Questions and answers

Tender material and financial concerns

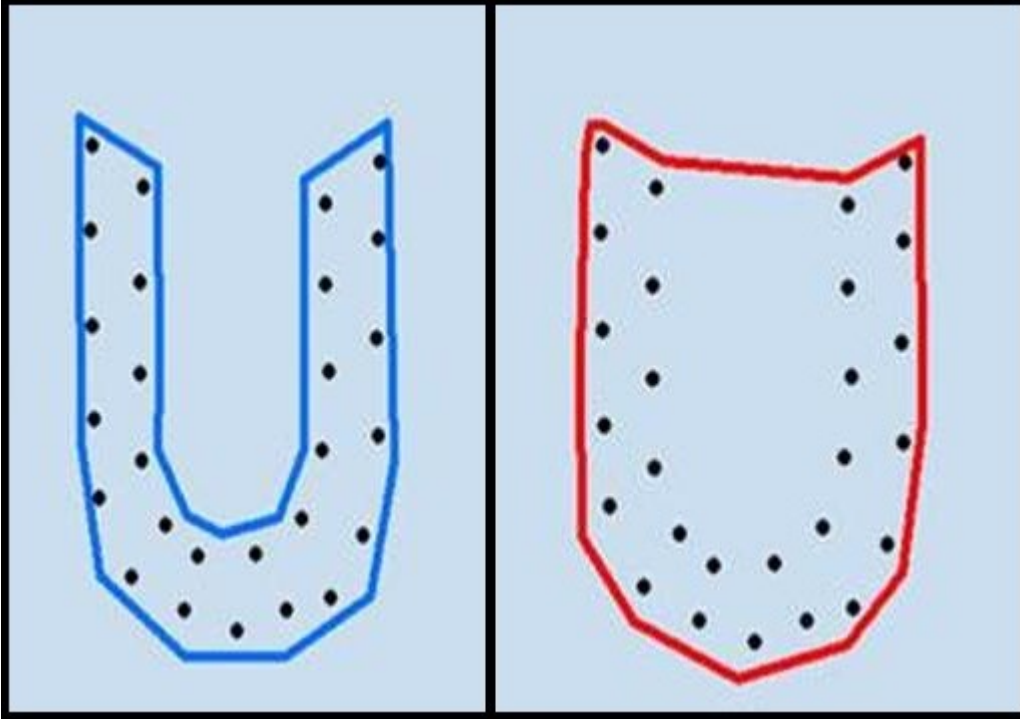
Besides this power cable there are privately owned cables which crosses some of the wind farm sites, but the Danish Energy Agency does not have access to information about these. The cables are the following:

Sæby: communication cables owned by Global Connect and TDC.

Sejerø Bugt: communication cable owned by Teliasonera.
